MEMO

Project Number	22-002 Masterton Private Plan Change
To	Megan Barr, 4Sight
Subject	Response to Further Information Request
Date	17 June 2022
Prepared by	Mitch Lewandowski

This memorandum addresses the matters raised by Masterton District Council in its Request for Further Information (RFI) dated 8 June 2022.

Figure 3. The Request site and nearby industrial zoning. Source: Masterton District Council GIS.

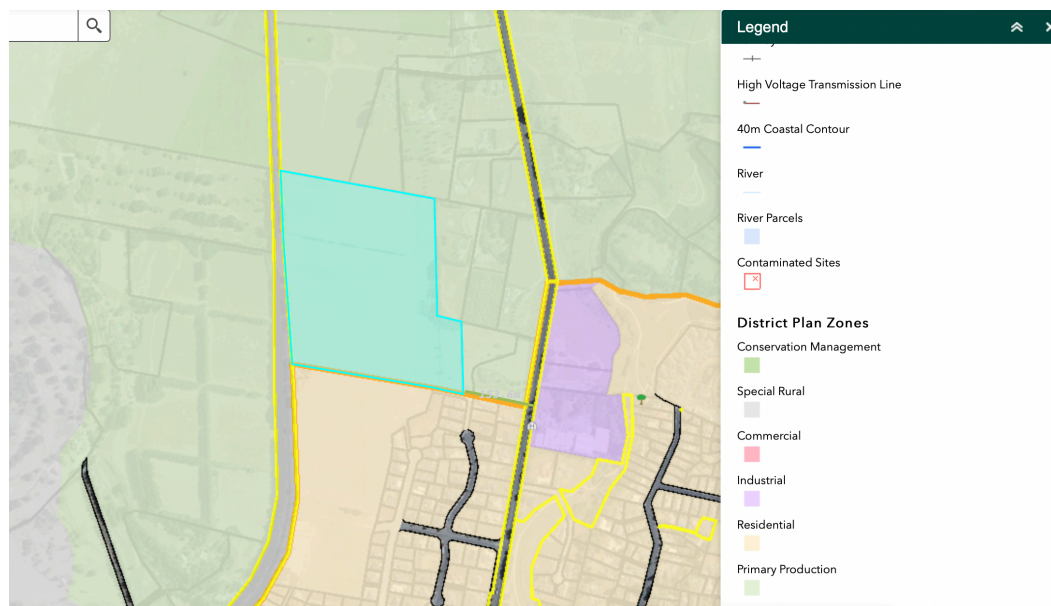
In respect of neighbouring industrially zoned sites, it is noted that the nearest industrial site is located some 150 metres from the closest boundary of the Request site, providing significant separation. That area of industrial zoning is also immediately surrounded by existing residential zoning as shown below.

Standard 7.5.2(e) specifies noise standards relevant to the industrial zone. The standards are measured at the notional boundary of any dwelling located on any site with the rural zone or at the boundary within any residential zone.

Given the separation of the site from the area of industrial zoning, the industrial site already being bordered by residential development, the presence of a retirement village within the area, and the noise controls already in place for the industrial zone, it is considered that no additional controls are required through the Request.

Figure 4. Reverse sensitivity mapping for State Highway effects. Source: Waka Kotahi/New Zealand Transport Agency.

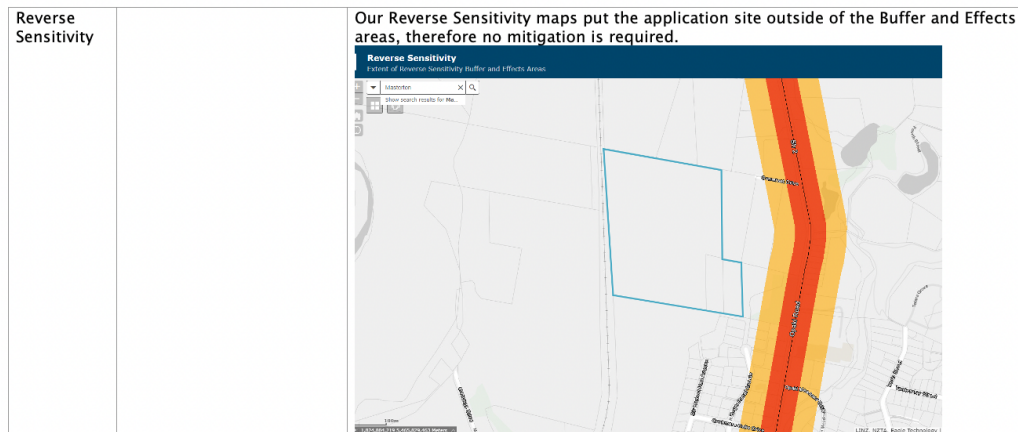
Consultation undertaken with the Waka Kotahi/NZTA, has confirmed that Waka Kotahi does not have concerns relating to traffic noise and reverse sensitivity from State Highway 2 as shown in Figure 4.
